DOWNTOWN DESIGN REVIEW BOARD

EARLY DESIGN GUIDANCE MEETING #2

600 WALL STREET

DPD# 3015251

LANDSCAPE PLAN

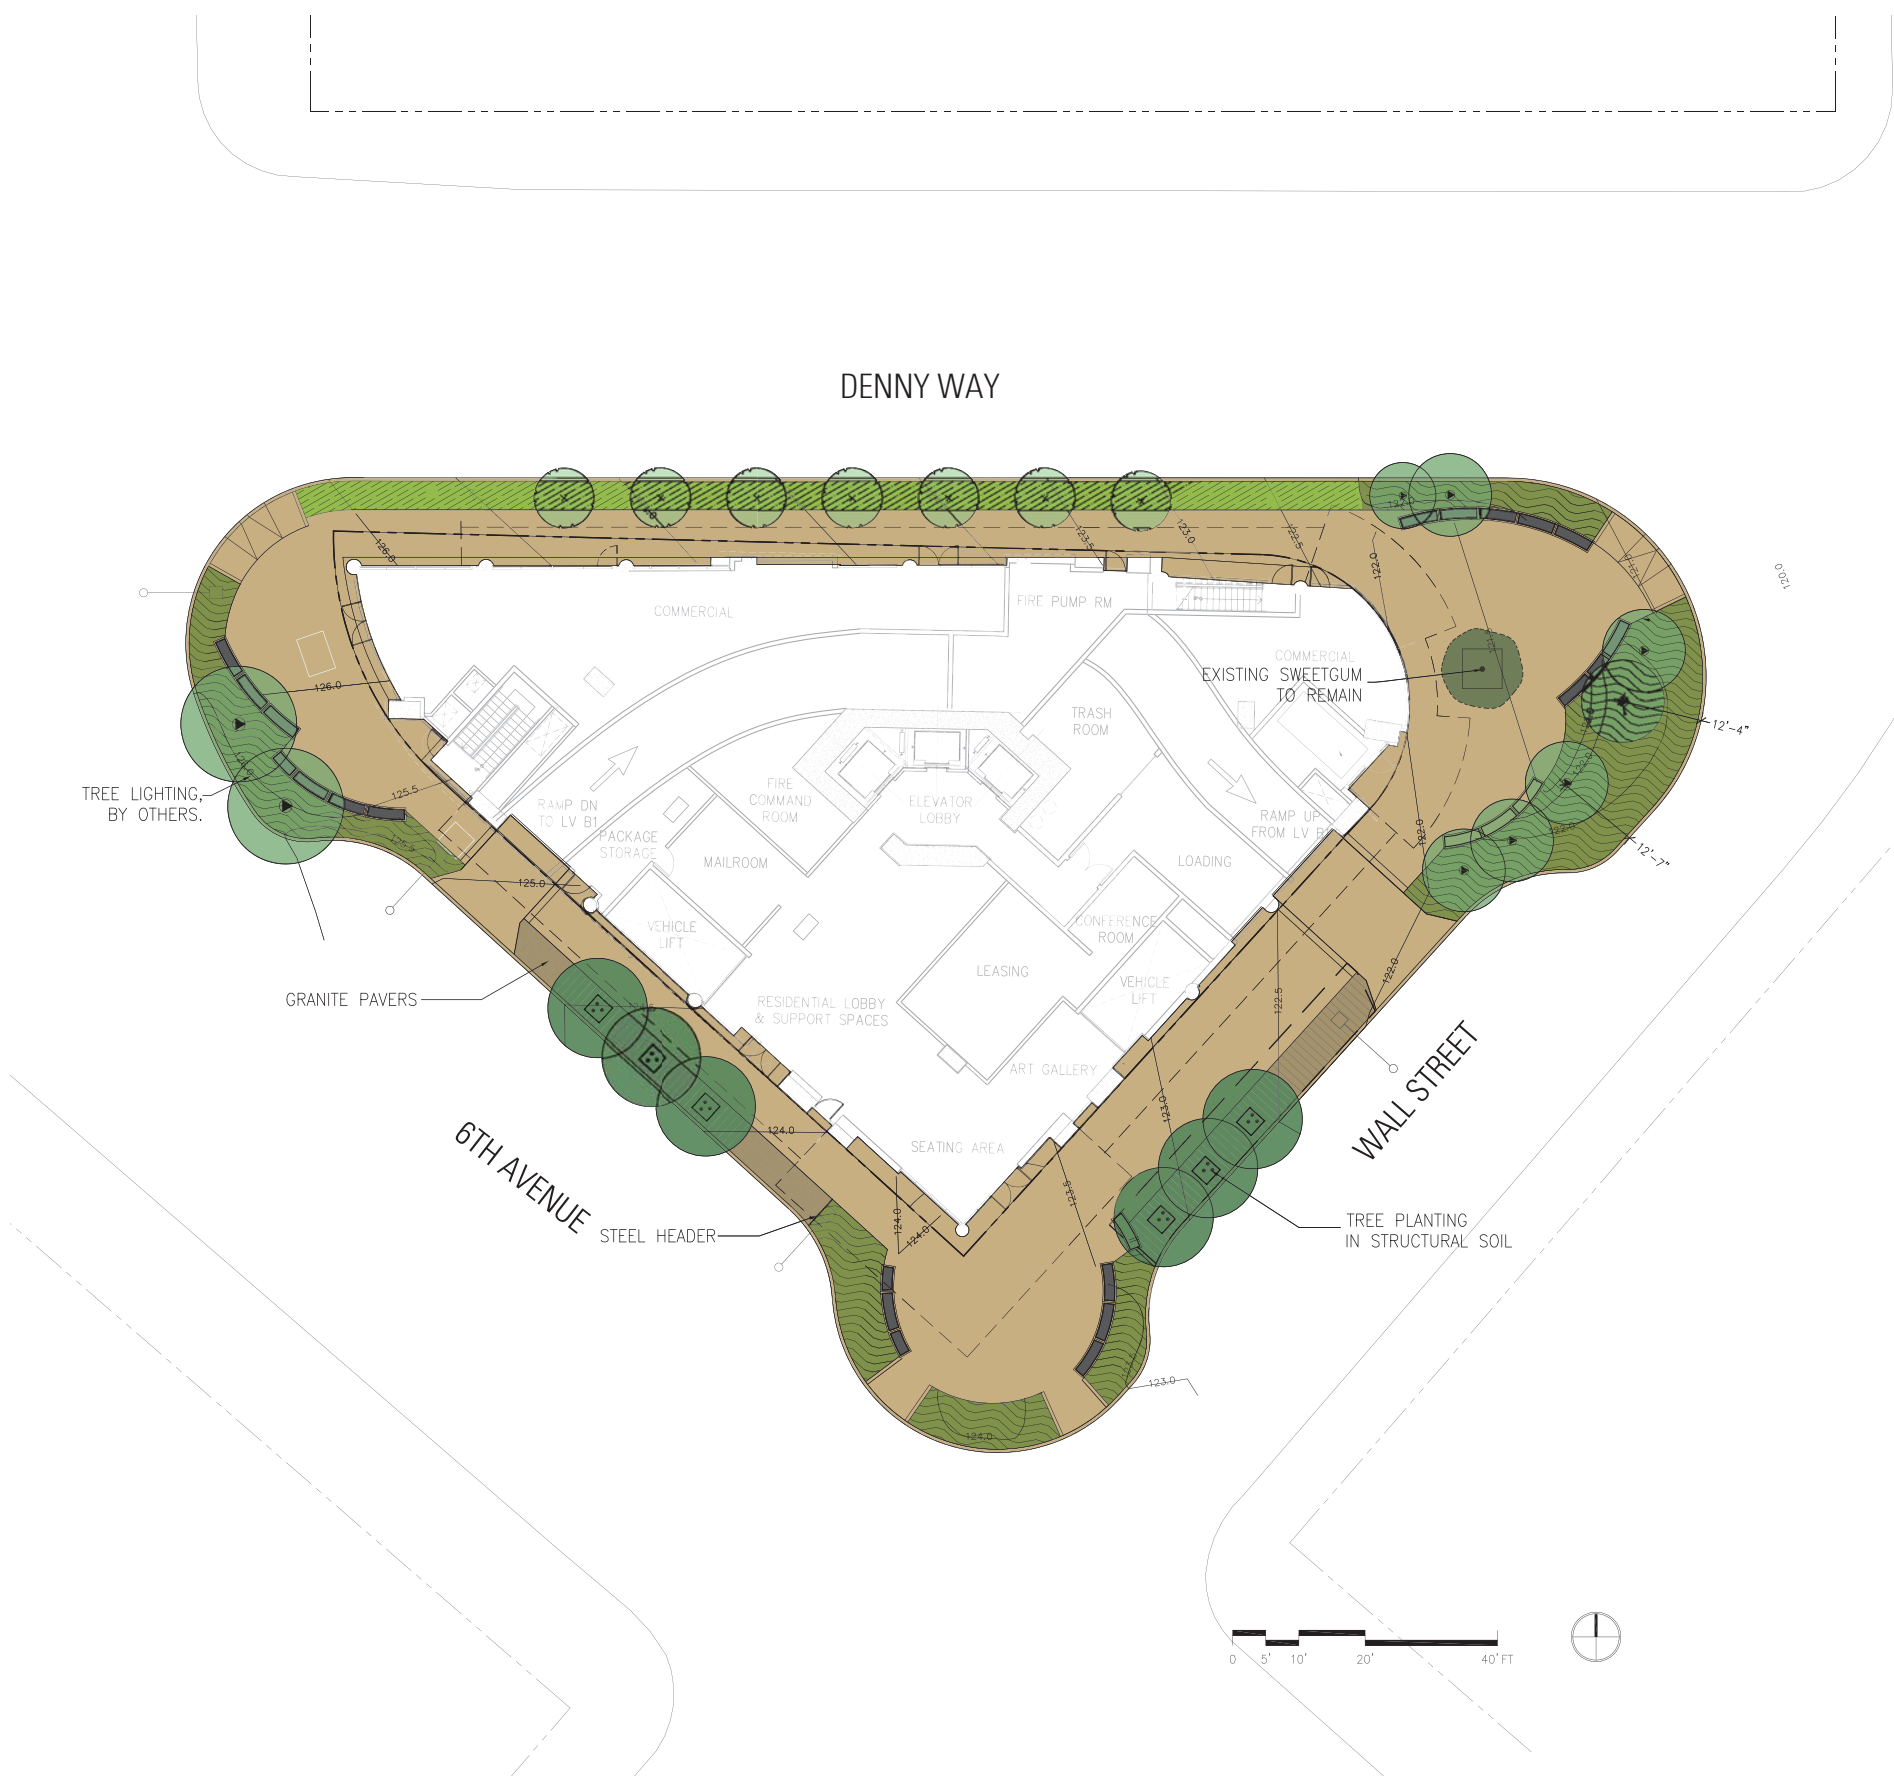
- We have revised the landscaping plan to provide additional pedestrian buffer along Denny Way as well as to provide additional pedestrian amenity for the retail space at Wall and 6th Ave.

- The landscape design has been revised. Hardscape paving design accentuates plazas and building entrances. Vertical design elements along Denny help create a buffer between the street and sidewalk.

1. Paving accents at corners
2. Paving accent at residential lobby

DIAGRAM C
Proposed Departure

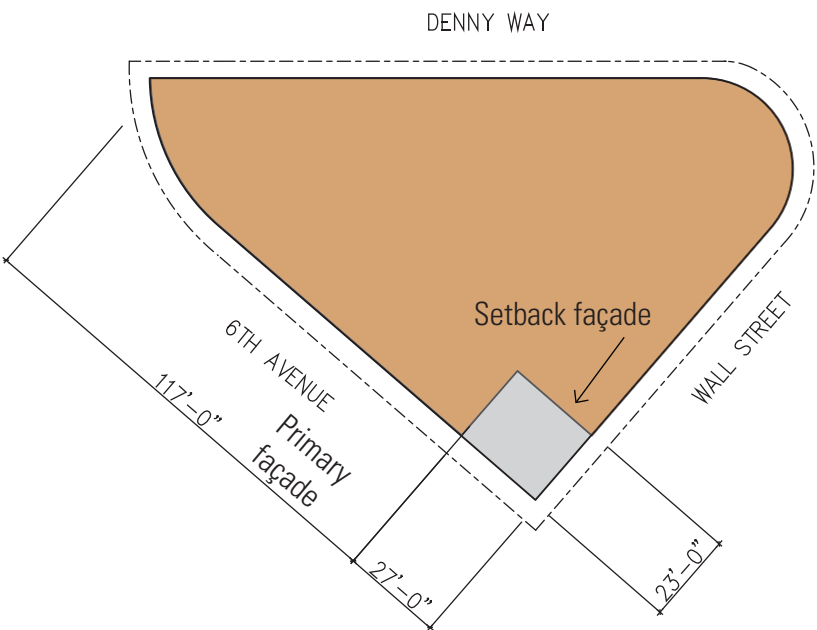
Development Standard	B. Requirement	C. Proposed	Rationale
23.49.058D.2	In DMC zones, the maximum facade width for portions of a building above 85' along the general north/south axis (parallel to the avenues) shall be 120' or 80% of the width of the lot, which ever is smaller. On lots smaller than 10,700 sf the facade width shall be 120'	The proposed design along 6th Ave. would have a facade width of 144', of which 27' of the facade would be set back 23' from the property line. The result would be that 117' of the facade would be on the property line.	<p>A fully compliant fa ade width would result in a termination of the building approximately 24' from the corner of Denny and 6th. The resultant cut would be detrimental to the flatiron design opportunities that this triangular site provides. The proposed concept would result in a flat primary fa ade length of 117' with a 27' setback fa ade at Wall and 6th, which is set back 23' from the primary fa ade (see Diagram C).</p> <p>Also, a portion of the fa ade curves back from the flat plane towards Denny Way to reduce the visual impact (see Diagram C).</p> <p>The proposed building notch at the corner of 6th and Wall not only reduces the length of the flat fa ade along 6th Avenue, but also significantly reduces the fa ade length along Wall Street, thus resulting in a slimmer building profile.</p>

Proposed Departure for 6th Ave.

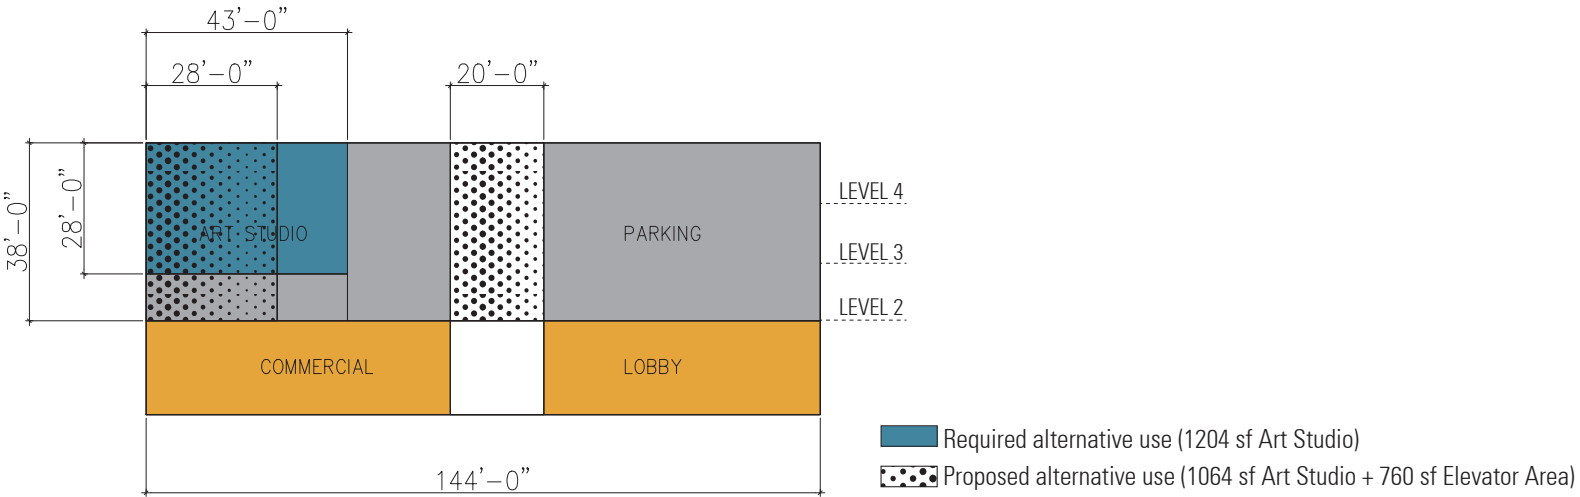
Development Standard	Requirement	Proposed	Rationale
23.49.01.2	(2) Parking above the third story of a structure shall be separated from the street by another use for a minimum of thirty (30) percent of each street frontage of the structure. For structures on lots located at street intersections, the separation by another use shall be provided at the corner portion(s) of the structure.	A departure is requested to reduce the alternative use minimum of 30% street frontage above level 3 along 6th Ave to 20% frontage use separation over levels 2 through 5. Along Wall Street the frontage use separation is 20% over levels 2 through 5. The facade area on 6th Avenue would be approx. 11% less than required and approximately 15% less than required on Wall Street. If the car elevator is allowed as an alternative use then the required lengths and areas would exceed minimum requirements.	The above grade automated parking system provides stacking for five levels (38' floor to floor) at close to the same height as a conventional parking structure with four levels (37' floor to floor). There will not be any visible vehicular movement or light glare from automobiles. There also will not be a need for exterior natural ventilation for car exhaust since cars will be transported by a mechanical system. We also propose to expose the vertical car elevator to public view from the street. The car elevator will be illuminated with low level LED lighting. Patterned clear and colored glass panels will provide an animated glass art mural, which will represent a distinctive visual break within the facade.

Development Standard	Required	Proposed w/o Elevator	Proposed w/ Elevator
	6th Ave.		
Facade Height	28' (Levels 3,4,5)	38' (Levels 2,3,4,5,6)	38' (Levels 3,4,5,6)
Facade Length	144'	144'	144'
Length of Alternative Use	30% alternative use required = 43.2'	28' (19%)	48' (33%)
Area of Alternative Use Above 2nd Floor	Area of alternative use above 3rd floor = 43.2' x 28' = 1,210 sf	28' x 38' = 1,064 sf	28' x 48' = 1,344 sf

Comparative Parking Sections

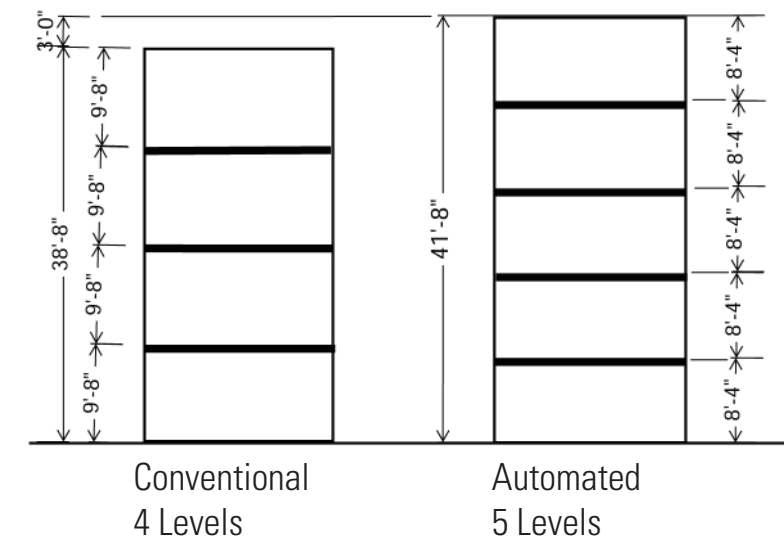
Development Standard	Requirement	Proposed	Rationale
23.49.019.2.A.1	One (1) story of parking shall be permitted above the first story of a structure for each story of parking provided below grade that is of at least equivalent capacity, up to a maximum of four (4) stories of parking above the first story.	A departure is requested to allow 5 levels of automated parking above the first floor.	WASHDOT has established an area around the tunnel in which no construction is allowed (see adjacent diagram). By special dispensation, WASHDOT has agreed to allow the tiebacks for our below grade garage to encroach a certain distance into the no-construction area. This allows us 6 parking levels only below grade. The 5 levels of above grade parking are contained within a height (41'-8"), which is only slightly greater than the height of a 4 level conventional parking structure (38'-8").
